CITY OF ALBUQUERQUE

INTER-OFFICE MEMORANDUM

TO: Dan Lewis, President, City Council
FROM: Alan Varela, Planning Director 
Alan Varela (Sep 9, 2024 11:17 MDT)
SUBJECT: **AC-24-24**, VA-2024-00233, PR-2022-006844,
BP-2024-10295, BP 2024-15349, BP-2024-15353

Martin Vigil appeals the Site Plan-Administrative decision to approve a Site Plan for all or a portion of TRACT A THE PEARL ADDITION (being a replat of Tracts 107-B, 107-C together with Tract 106-A within projected Section 18 T10 N, R3E) zoned MX-M and R1-A, located at 1701/1623 Central Avenue, NW containing approximately 0.5767 acre(s). (J-13)

Figure 2. The building location shown to be more than 50 feet from R1-A zoned lots.

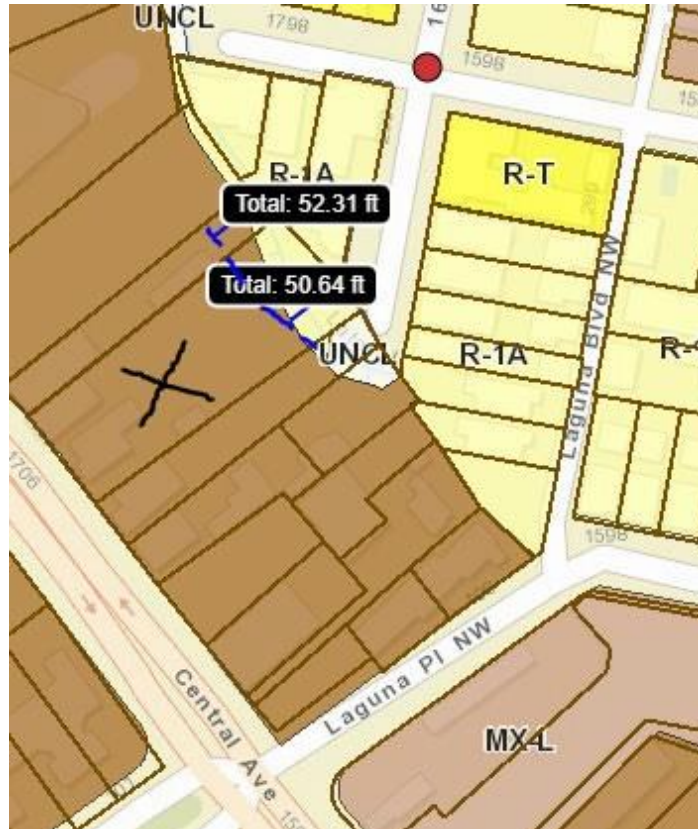
6. **Appellant:** Building height is limited to 30 feet in height in the Premium Transit Corridor. The proposed development is 48 feet high within 50 feet of existing single-family. The 4-story structure will be the tallest building on the block and does not conform to the pre-existing neighborhood or CPO-3.

Staff Response: The appellant is referring to IDO Section 14-16-5-9, a provision for Neighborhood Edge buffers. Protected lots must be zoned R-A, R-1, R-MC, or R-T and must contain low-density residential development. The proposed multi-family building is on the MX-M portion of the site making it a regulated lot. Central Avenue is both a Main Street and Premium Transit corridor, so the building could not be taller than 30 feet within 50 feet of a protected lot line. The proposed building is 48 feet tall, but the building is farther than 50 feet to any property zoned R-A, R-1, R-MC, or R-T. (See the map below.) The blue line shows a measurement 50 feet from the north property line; the black 'x' shows the general location of the 48-foot tall building. It is also noted that

the residential homes to the east and west are on parcels zoned MX-M and are not protected lots. Therefore, the 48-foot tall building is located on the lot where it is compliant with the IDO.

Figure 3. The site layout. The building is shown in light blue, yellow, and some of the purple. Central Avenue is at the bottom of the figure and the connection to 16th Street is shown at the top.

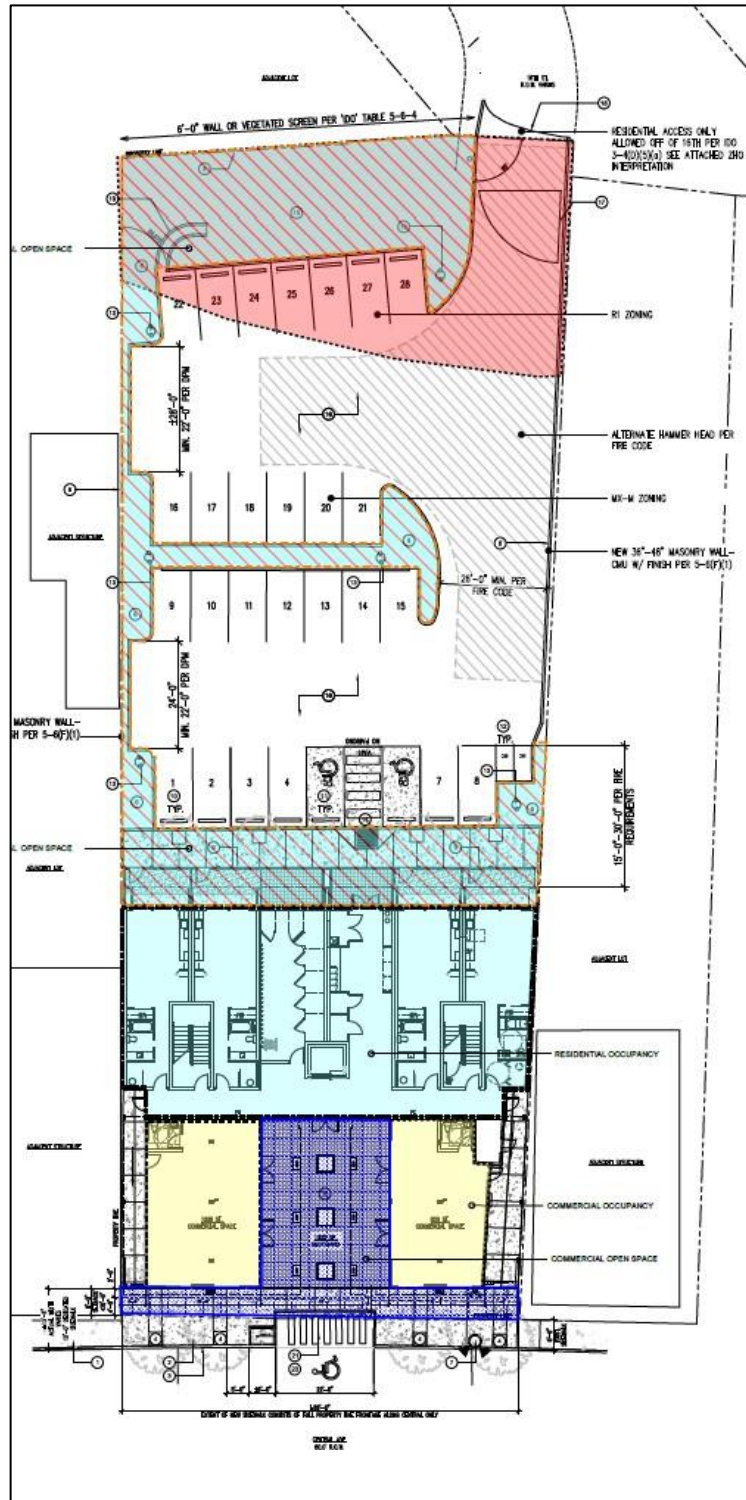
7. **Appellant:** A 0-foot setback on the west and east sides are not allowed in the IDO, page 111.

Staff Response: The page cited does not apply as it references the CPO-12 - Sawmill/Wells Park Overlay zone and does not apply to CPO-3 the Downtown Neighborhood Area. Per IDO 14-16-3-4(D)(3)(c)(2)(a), CPO -3 allows 0-feet interior side setbacks on both the east and west property lines. The proposed building is compliant with IDO setbacks.
